H. B. ROBINSON STEAM ELECTRIC PLANT UNIT NO. 2
DOCKET 50-261

LICENSE NO. DPR-23

REQUEST FOR LICENSE AMENDMENT - REVISION OF TECHNICAL SPECIFICATION

Figure 3.1-1 REACTOR COOLANT SYSTEM HEATUP LIMITATIONS - APPLICABLE FOR PERIODS UP TO 20 EFFECTIVE FULL POWER YEARS

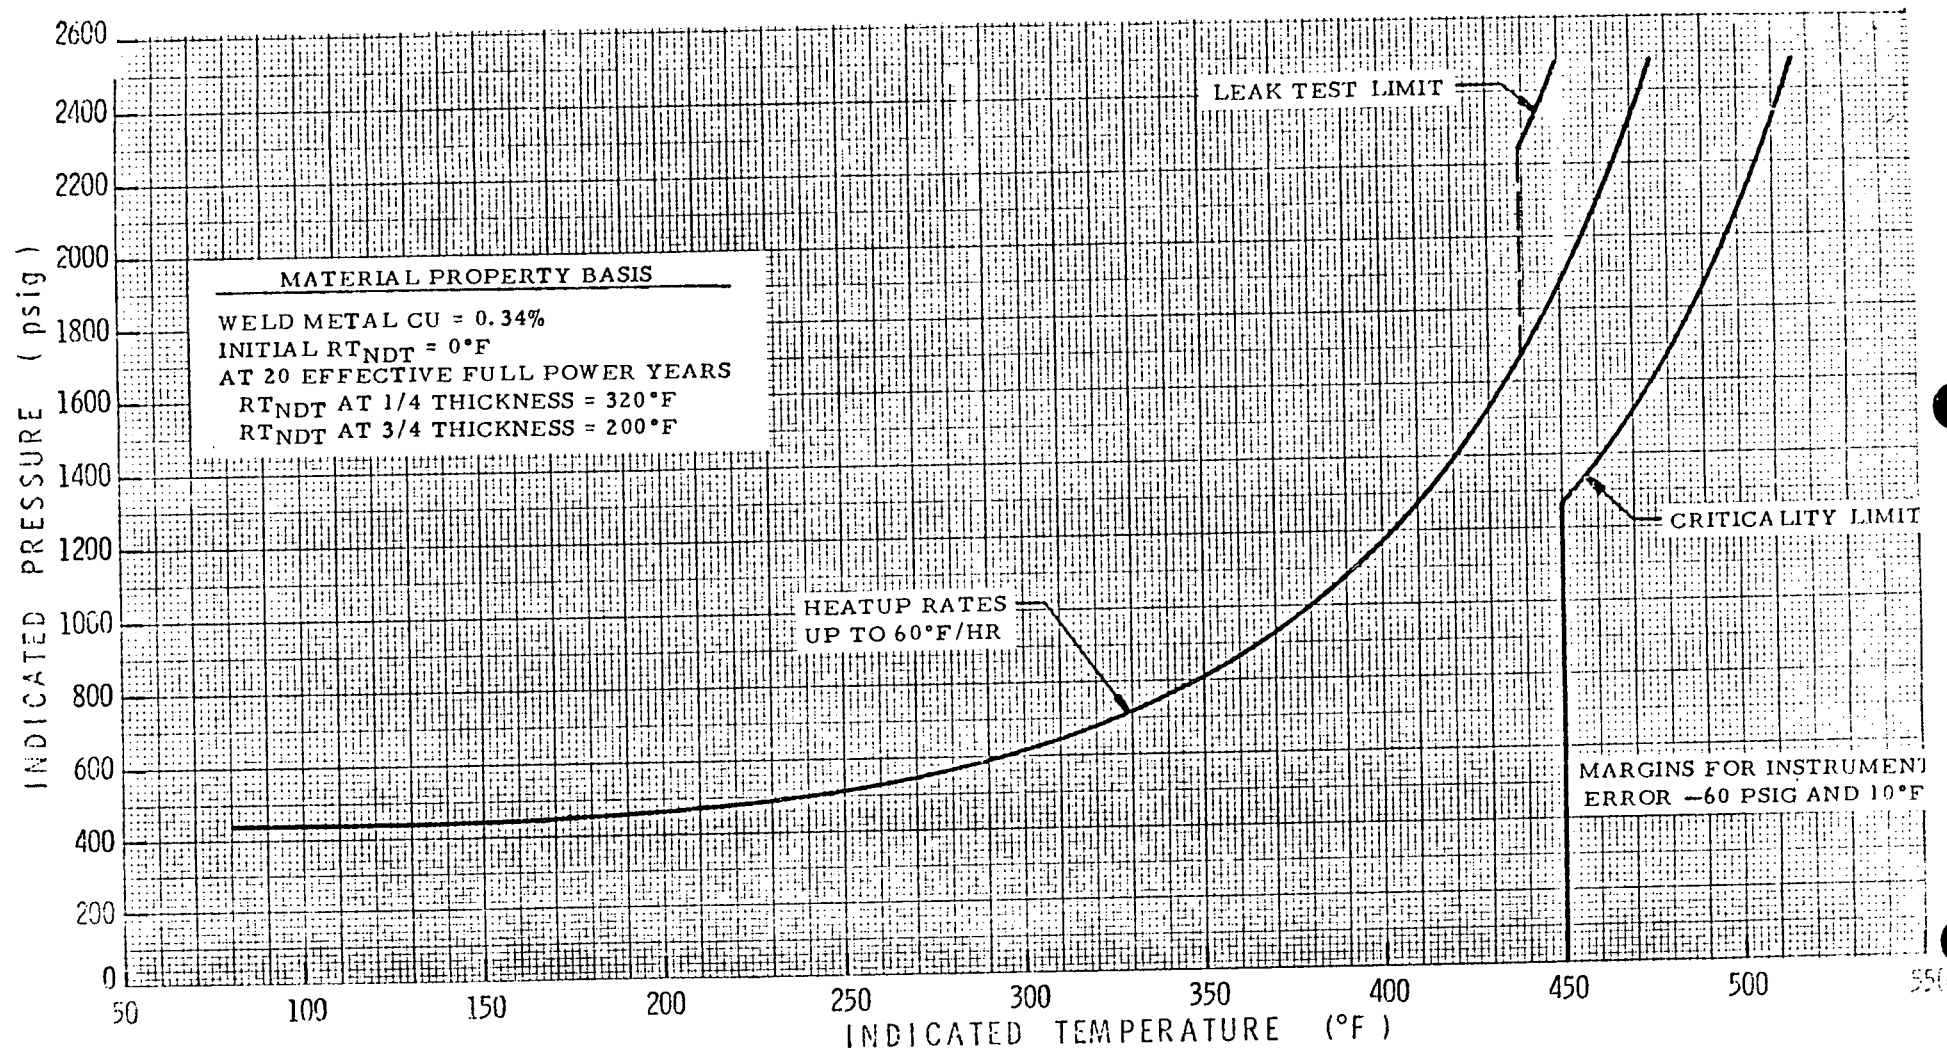
In accordance with the Code of Federal Regulations, Title 10, Part 50.90 and Part 2.101, and Technical Specification 3.1.2.4, Carolina Power & Light Company (CP&L) hereby requests a revision to the Technical Specifications for H. B. Robinson Unit 2. This revision incorporates new heatup and cooldown curves resulting from analysis of samples in the irradiation specimen measurement program.

The revised heatup and cooldown curves derived from this analysis are attached as replacement pages for the unit Technical Specifications. Other replacement pages simplify the bases for this section by deleting some discussion which is merely copied from the referenced reports.

The changes are indicated by vertical lines in the margin of the attached pages. We request your prompt attention to this revision since the applicability of the present heatup and cooldown curves extends only to approximately February 11, 1976.
